# ABINGTON TOWNSHIP

## PLANNING COMMISSION MEETING

- a. Review the Preliminary/Final Major Subdivision and Land Development for LD-23-03 - 1583 Rothley Avenue.

**RE: Executive Summary for LD-23-03-1583 Rothley Avenue**  
**PARID: 30-00-60076-00-5/ TMID: 30200 002**  
**PARID: 30-00-60072-00-9/ TMID: 30200 003**  
**Preliminary/Final Major Subdivision & Land Development Plans Review (2<sup>nd</sup> Submission)**

COVER SHEET  
OF  
1583 ROTHLEY AVENUE  
PREPARED FOR  
DOLSON, LLC  
ABINGTON TOWNSHIP, MONTGOMERY COUNTY, PA.

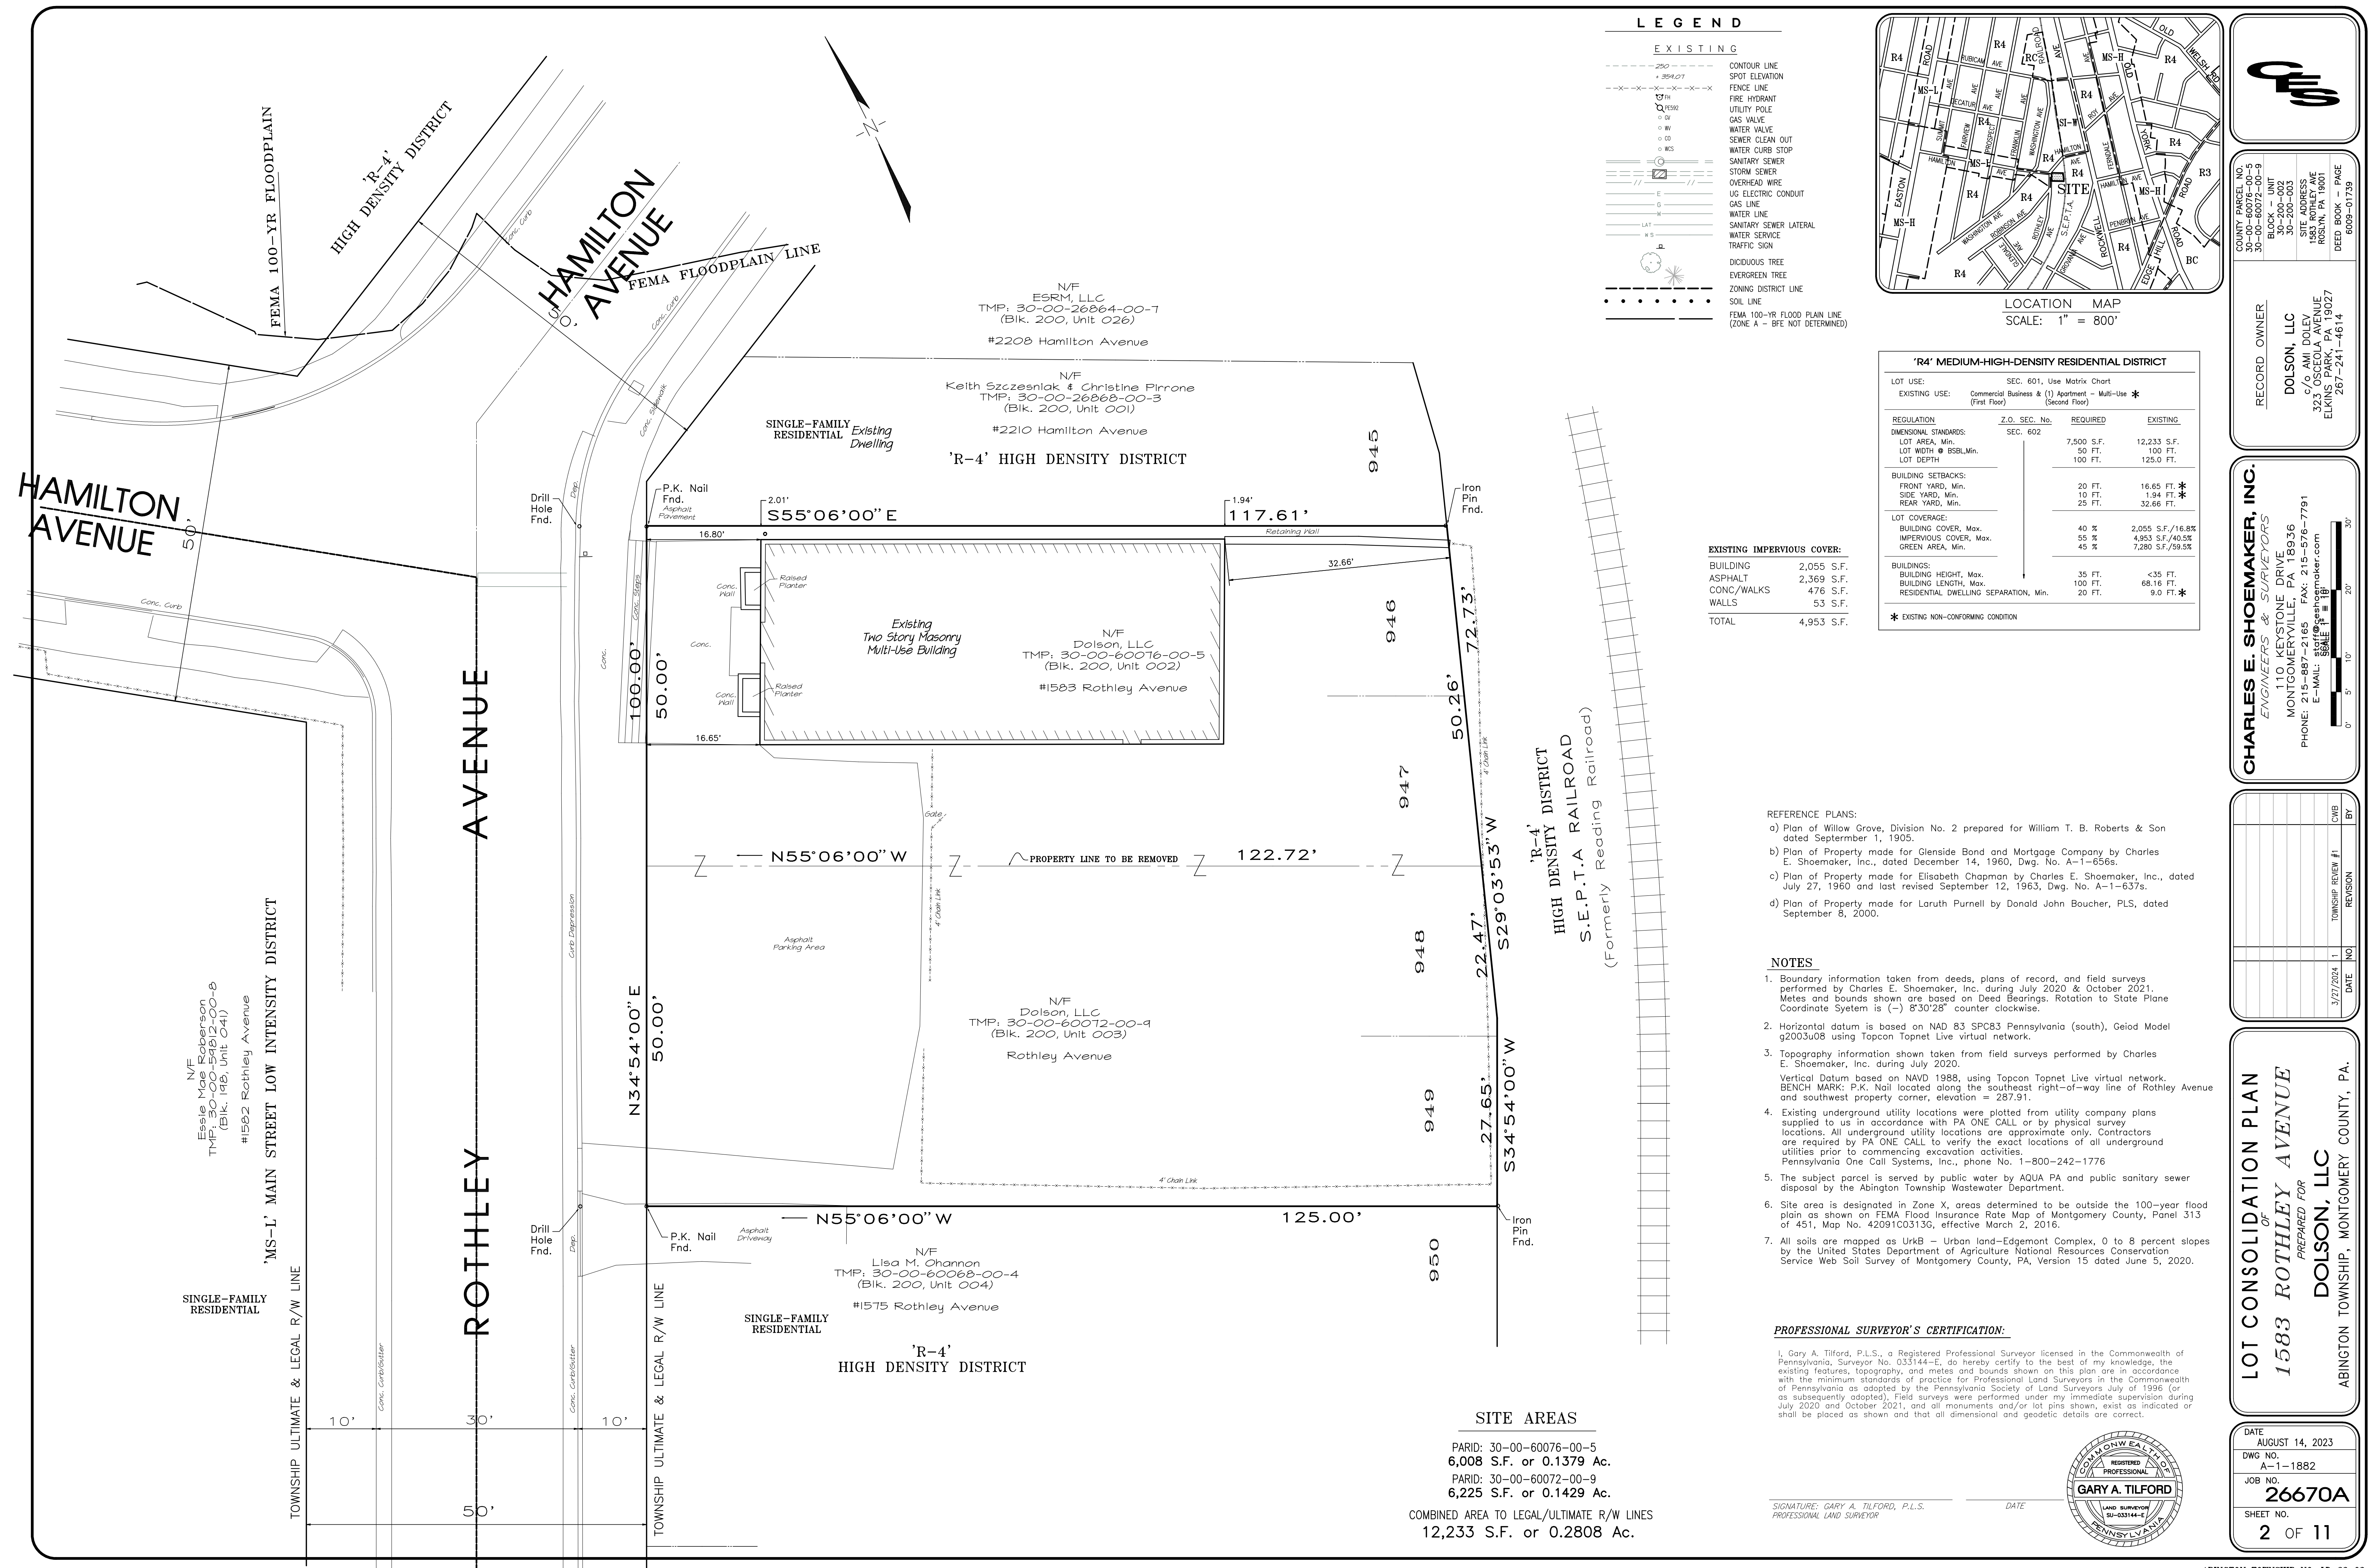
25. **Per §146-12.B.(5) – Record Plan Seals** – The impressed seal of the Township Engineer shall be provided on the Cover Sheet (Sheet 1).

26. **Per §146-12.E – Recording notations** – The plans shall provide the recording notations as indicated in this Code Section on the Cover Sheet (Sheet 1).

25. **Per §146-12.B.(5) – Record Plan Seals** – *The impressed seal of the Township Engineer shall be provided on the Cover Sheet (Sheet 1).*

26. **Per §146-12.E – Recording notations** – *The plans shall provide the recording notations as indicated in this Code Section on the Cover Sheet (Sheet 1).*

**The notations as indicated in §146-12.E.(2) thru (6) shall be included on the Cover Sheet (Sheet 1).**

**LOT CONSOLIDATION PLAN**  
OF  
**1583 ROTHLEY AVENUE**  
PREPARED FOR  
**DOLSON, LLC**  
ABINGTON TOWNSHIP, MONTGOMERY COUNTY, PA.

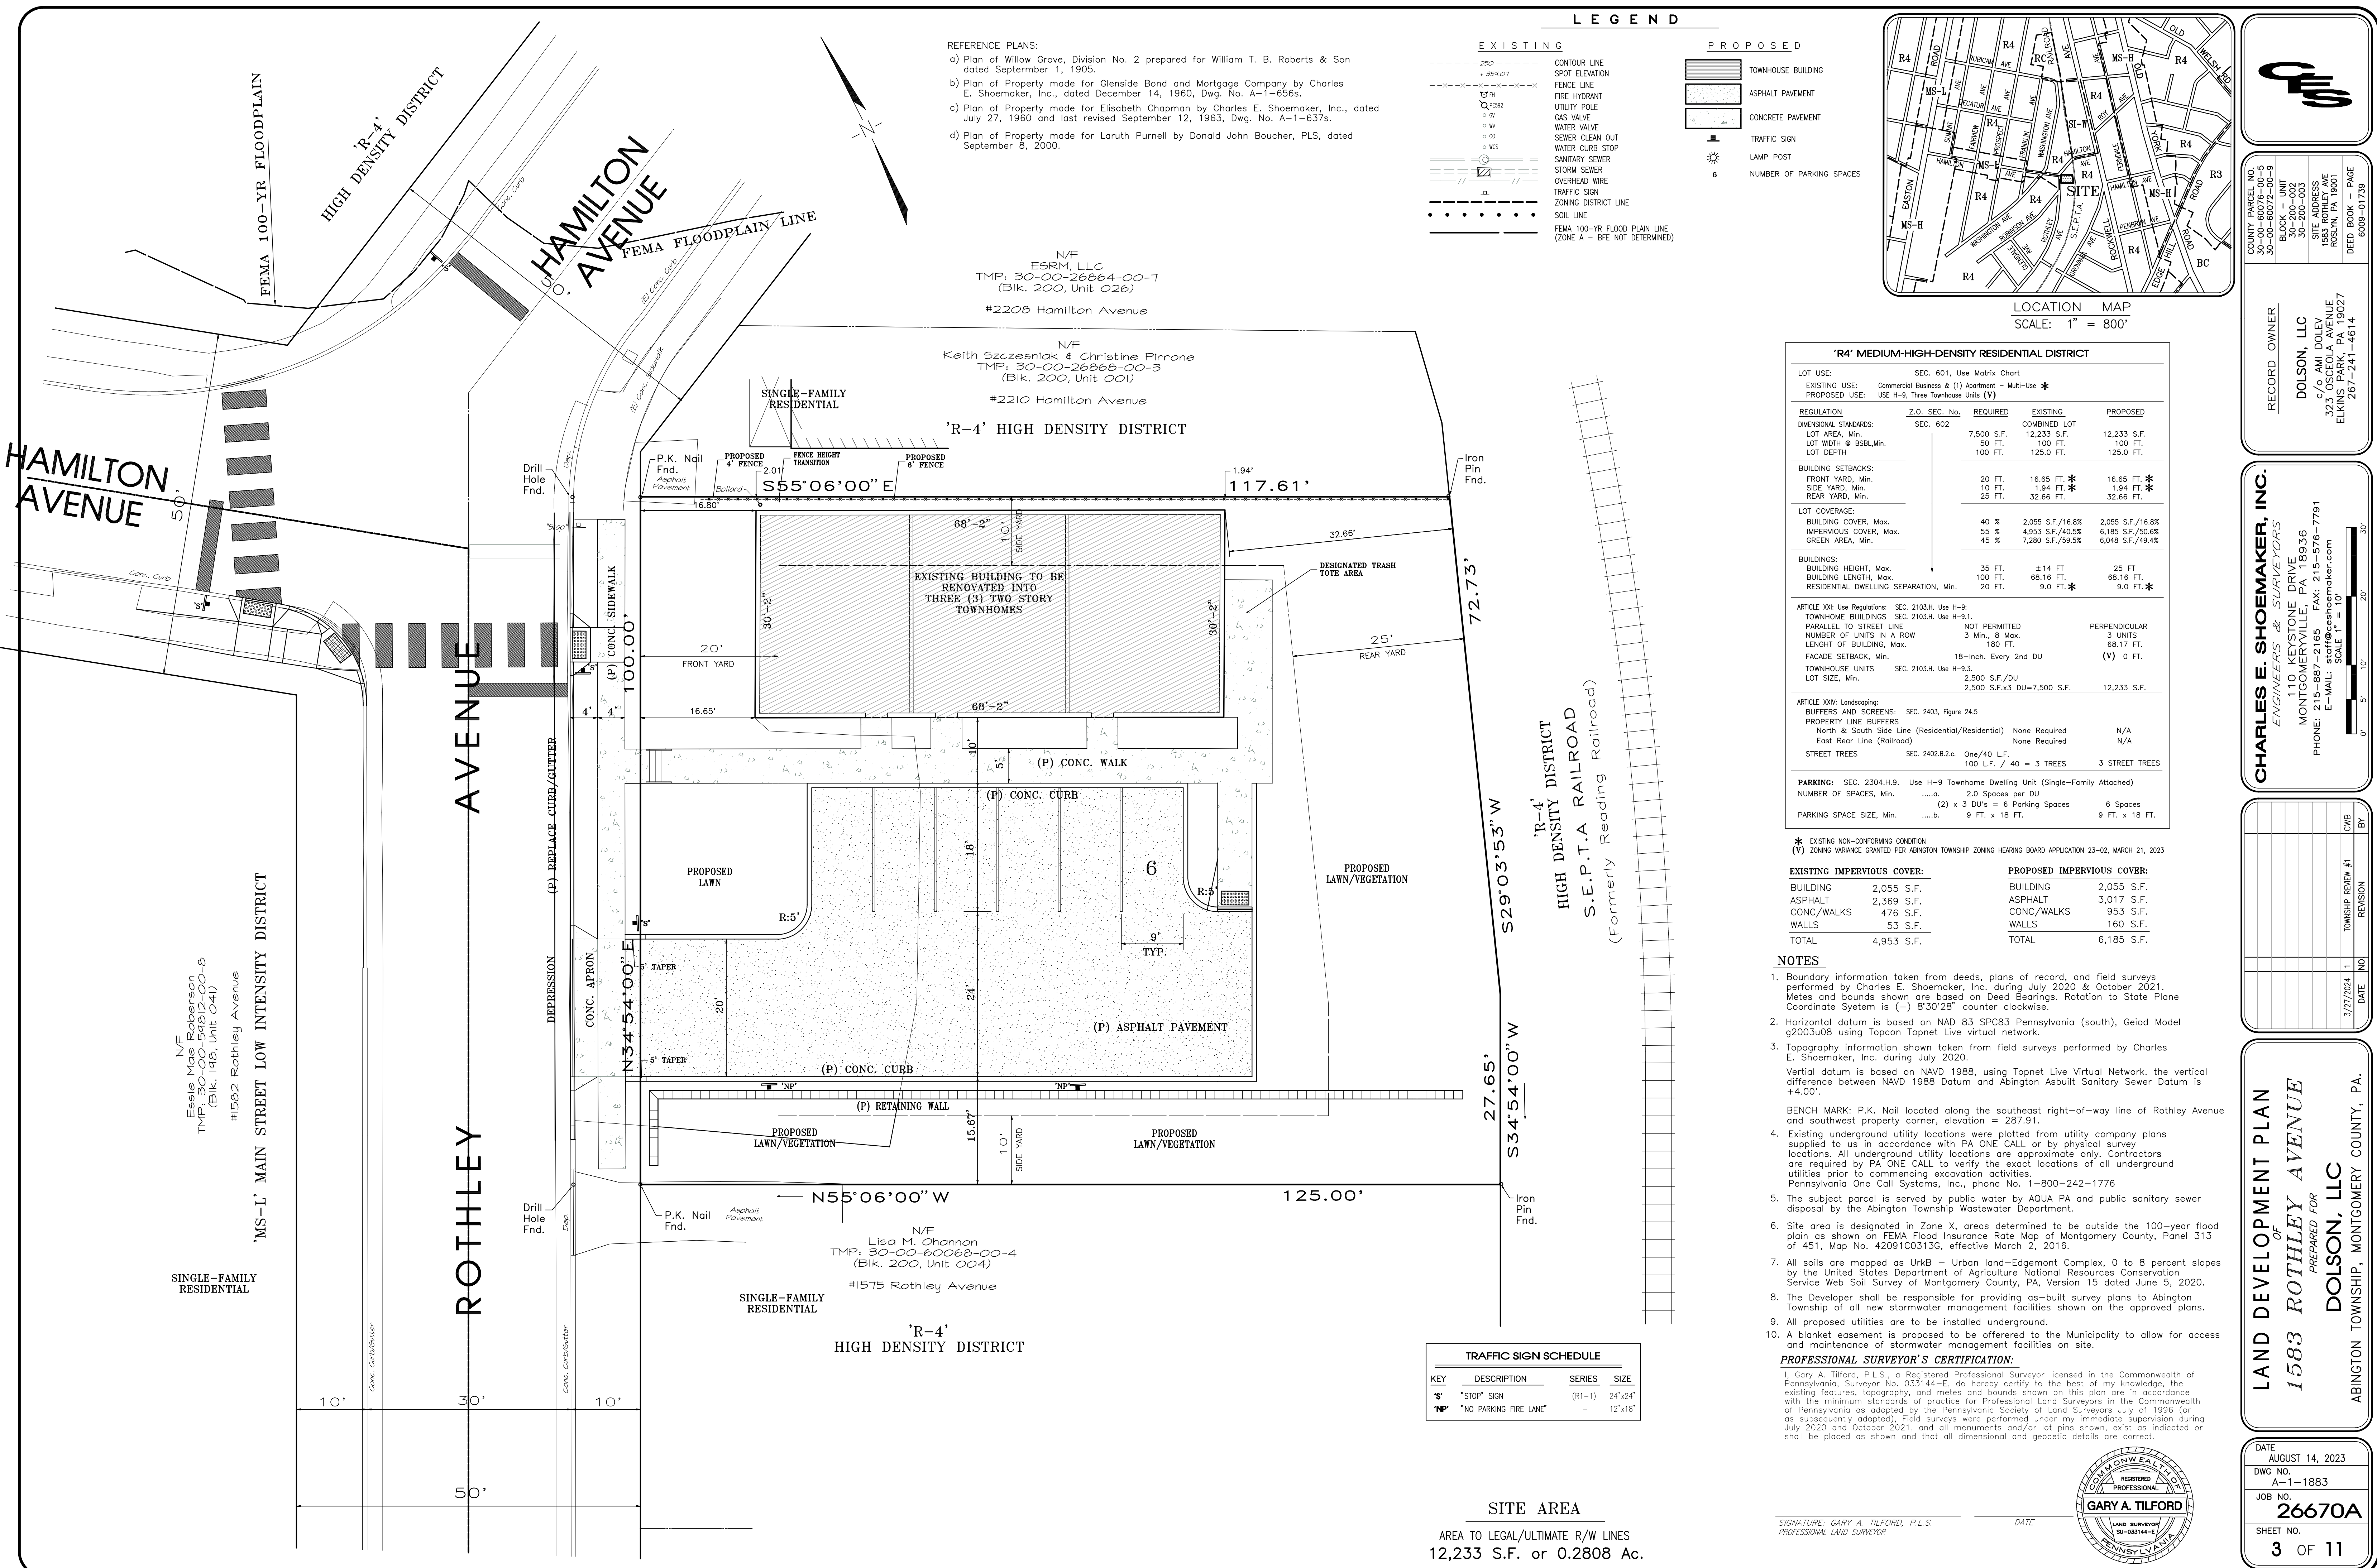
**Based on the notes on the Subdivision Plan (Sheet 2), the vertical datum on the plans is based on NAVD 1988. The elevations shall be based upon the sanitary sewer datum of Abington Township per this Code Section. The Applicant shall either provide the elevations based on the sanitary sewer datum of Abington Township; or provide a conversion reference note from the NAVD1988 to the Abington Township sanitary sewer datum on the plans.**
